NUCLEAR ENERGY INSTITUTE

**Subject:** Supplemental Information to Nuclear Energy Institute Comments Submitted on January 20, 2010 on U.S. Nuclear Regulatory Commission Draft Regulatory Guide DG-1199, "Alternative Radiological Source Terms for Evaluating Design Basis Accidents at Nuclear Power Reactors" (*Federal Register* of October 14, 2009, 74 FR 52822).

## **BWR Steam Line Radionuclide Concentration Distribution following a DBA LOCA**

Figure 4 – Figure 3 with DBA-LOCA (No Sprays) CsI Airborne Activity Superimposed

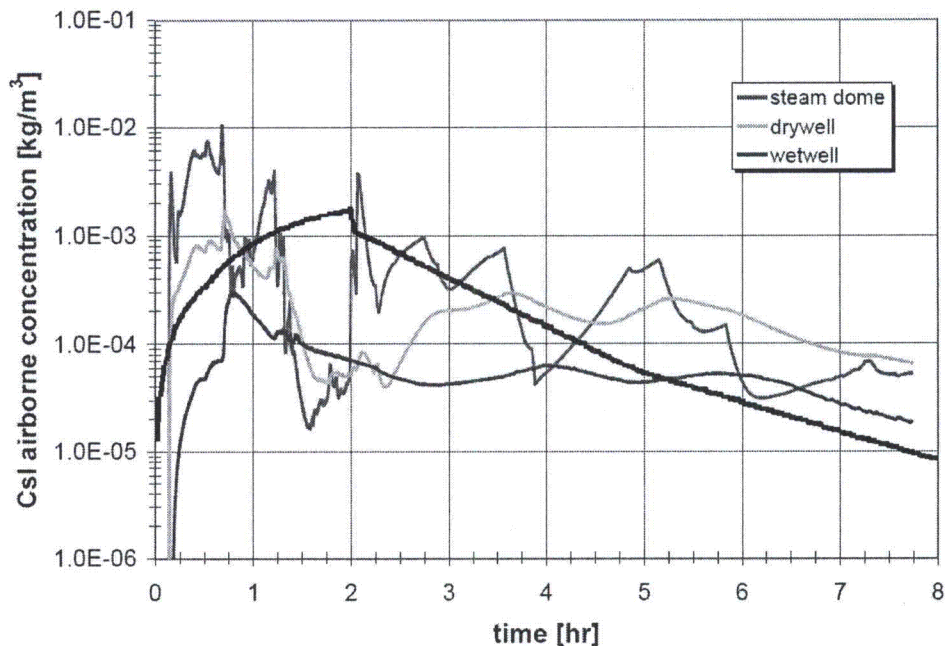
There are a number of points to be made concerning Figure 4:

- First, at  $t = 2$  hours the drywell DBA-LOCA CsI concentration is very close to the MELCOR result as long as the suppression pool and wetwell estimated inventory is added to that in the drywell (i.e., the  $1.6\text{E-}3 \text{ kg/m}^3$  equivalent CsI mass estimated to be in the suppression pool + the  $\sim 7\text{E-}5 \text{ kg/m}^3$  in the wetwell reduced by the drywell-to-wetwell volume ratio of about 1.67 + the  $\sim 5\text{E-}5 \text{ kg/m}^3$  in the drywell =  $1.7\text{E-}3 \text{ kg/m}^3$ ). In other words, the MELCOR total release to the

containment is very similar to that of the DBA-LOCA. The peak MELCOR concentration at  $t = 0.7$  hours is also very close to the peak DBA-LOCA concentration 1.3 hours later. Both of these observations are consistent with the MELCOR cases run in support of Reference [12].

- Second, Figure 4 demonstrates the steam dome activity concentration concern quite well (which is the central issue being addressed by this study). During the first  $\sim 1.3$  hours, the steam dome CsI concentration substantially exceeds that of the drywell for both the DBA-LOCA and the MELCOR case. For the DBA-LOCA analysis, the worst two hours – in terms of airborne CsI available for leakage from the drywell – would appear to be from about one hour to about three hours. This would be a typical time for the worst two-hour EAB dose to be calculated for an actual DBA-LOCA analysis. If the source were the steam dome, however, the worst two-hour period would appear to be from about 0.2 hours to about 2.2 hours, and the dose could be several times higher for the steam dome case (based on integrated area under the curve from 0.2 to 2.2 hours for the steam dome and from one to three hours for the heavy black line of the DBA-LOCA drywell).

- Third, one may note that the MELCOR drywell concentration actually increases after about 2.3 hours (along with the concentration in the steam dome, which increases sharply about 0.3 hours earlier). These increases are indicative of a second release that appears to make the MELCOR-calculated release to containment after  $t = 2$  hours substantially greater than the AST (since the release up to  $t = 2$  hours appears to be virtually identical to the AST). For consistency with the AST, the MELCOR reflood should probably have been initiated at about  $t = 0.7$  hours, or shortly thereafter, when the activity release to the containment was approximately equal to that of the AST (as was the case in the MELCOR analyses supporting Reference [12]). Certainly, the assumed reflood should not be postponed beyond  $t = 2$  hours.

Figure 5 – Reproduction of Figure 2-31 from Reference [2] with DBA-LOCA (No Sprays) CsI Airborne Activity Superimposed

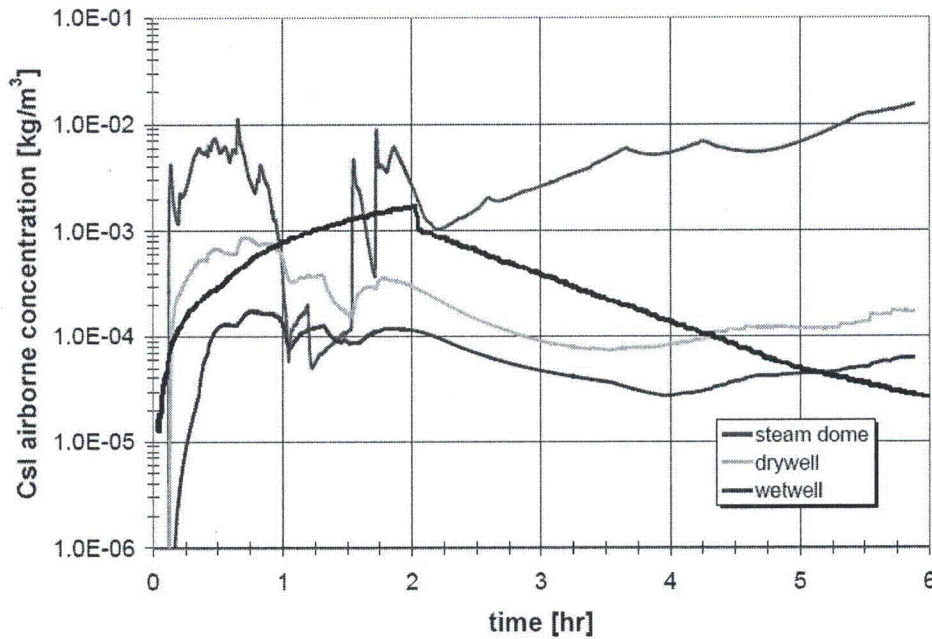
The situation is similar for the case of the recirculation system large-break LOCA. Figure 5 is identical to Figure 4 except it is based on Figure 2-31 of Reference [2] for the recirculation system large-break LOCA instead of the MSLB. Once again, the solid black line is the drywell airborne CsI concentration for the DBA-LOCA.

For the recirculation system break, the MELCOR analysis shows about 3.8 kg of CsI airborne in the drywell at the peak time of ~ 0.7 hours with an additional 0.7 kg of CsI in the wetwell. If this were all in the drywell, the CsI concentration would be about 1.0 kg/m<sup>3</sup>, about 60 percent of that for the steam line break, and less than the peak for the DBA-LOCA. However, the MELCOR analysis results indicate that at least another 2.0 kg of CsI is added before t = 2 hours. It's difficult to tell from the Reference [2] figures, exactly when the total MELCOR-generated CsI release to the containment for the recirculation system break would exceed 10.8 kg (30 percent release). It would likely take longer than the estimated 0.7 hours for the MSLB, but could still be less than t = 2 hours because of uncertainty about how much activity is in the suppression pool.

Figure 12 – NG and CsI Release to Environment for DW or SL as Source – MSLB-3CV

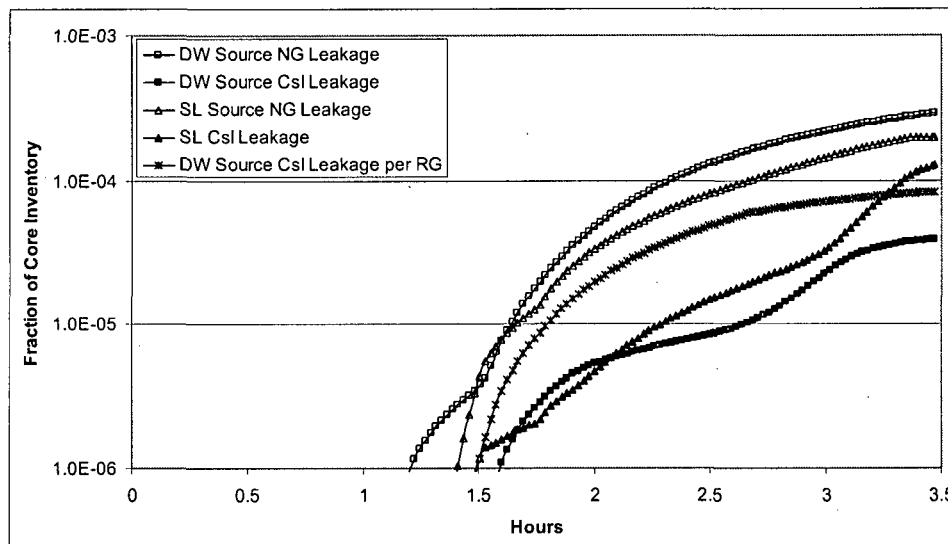
The key comparison is that provided by Figure 12. Here, one can see that the MSLB-3CV case run with the assumed source for the MSIV leakage being the drywell produces a noble gas leakage within the time frame of interest that is 1.55 times greater than that produced with the steam line (i.e., control volume SL3) assumed to be the source. (Note that the steam line leakage is estimated by subtracting the drywell-pathway noble gas leakage from the noble gas leakage for the combined drywell + steam line base case MSLB-3CV). For CsI, however, the situation is the opposite. The case run with the assumed MSIV leakage source being the drywell produces a leakage within the time frame of interest of just over 50 percent of that produced with the steam line assumed to be the source. This result, however, fails to recognize that the proper comparison is one in which the reference drywell activity is that consistent with the DBA-LOCA methodology (prohibiting, for example, credit for the transfer of activity from the drywell to the wetwell during the release period). When the proper comparison is made, the MSLB-3CV case run with the drywell as the assumed MSIV leakage source produces a CsI leakage (within the time frame of interest) 2.8 times greater than that produced with the steam line assumed to be the source. Therefore, the case with the drywell assumed to be the source is more limiting for both NG and CsI releases.

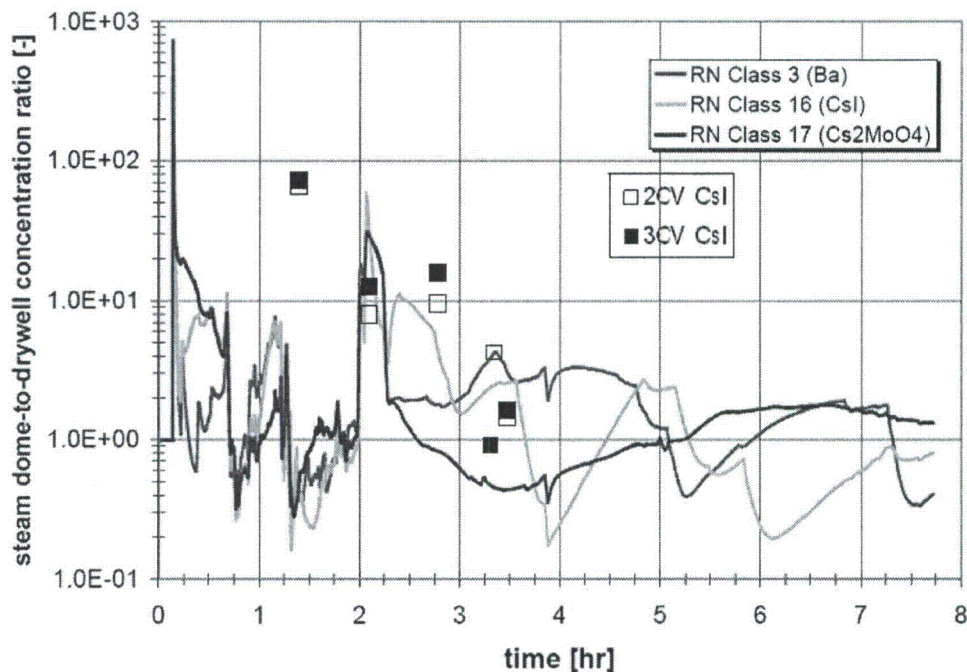
Figure 15 is a reproduction of Figure 2-15 of Reference [2] showing the steam dome-to-drywell concentration ratio for three fission product groups including that for CsI.

Figure 16 – CsI Concentration in DW, UH, and SL3 – MSLB-3CV

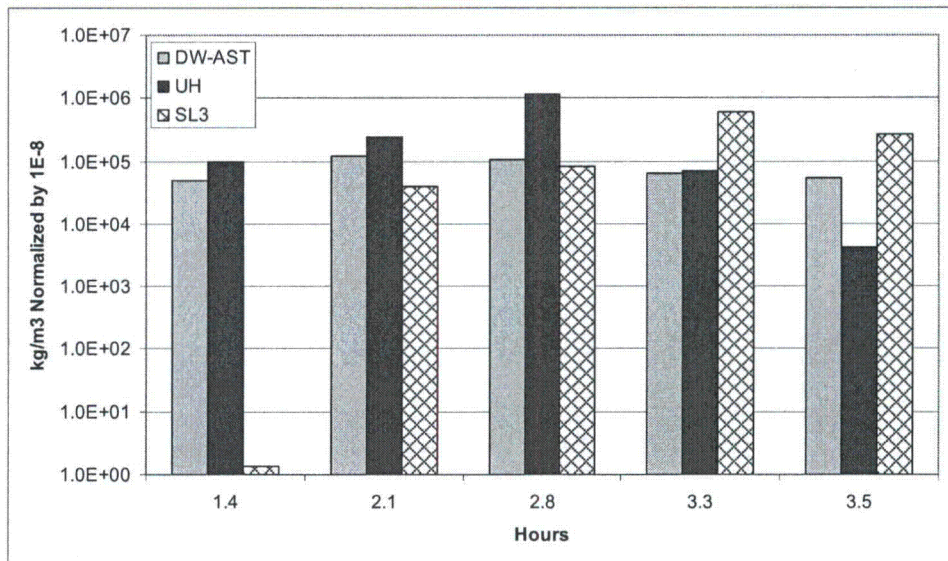
What this means is that while there is a benefit of suppressed mixing between the vertically-oriented control volumes during the time frame of interest, there is also a period of time after the core debris quench that the activity concentration at the MSIV leakage point will be significantly greater than that of the upper head and even of the drywell. This is seen in Figure 16.

Figure 16 also shows the drywell concentration corresponding to the AST with the start of release delayed (as depicted in Figure 9 and as permitted by Reference [3] for a break smaller than the largest break).

When considering Figure 16, one must recognize that by 2.8 hours, the AST release to the containment is complete and the MAAP4-calculated CsI release to containment has already exceeded the AST value of 30 percent. Therefore, the debris quench that occurs at t = 3.3 hours due to core debris relocation in the MAAP4 calculation should have been forced to occur not later than about 2.8 hours (by restarting the ECCS) to limit the MAAP4-calculated CsI release to containment to 30 percent. Nevertheless, even if the behavior in question occurs well after the time frame of interest, it's worth pointing out the significant increase in the CsI concentration in SL3 even as the CsI concentration is

When comparative studies are made of the drywell vs. steam line release pathways and the ECCS reflood is initiated at a point in time that limits the iodine release to containment to 30 percent, provision must be made to account for the activity trapped in the steam lines.
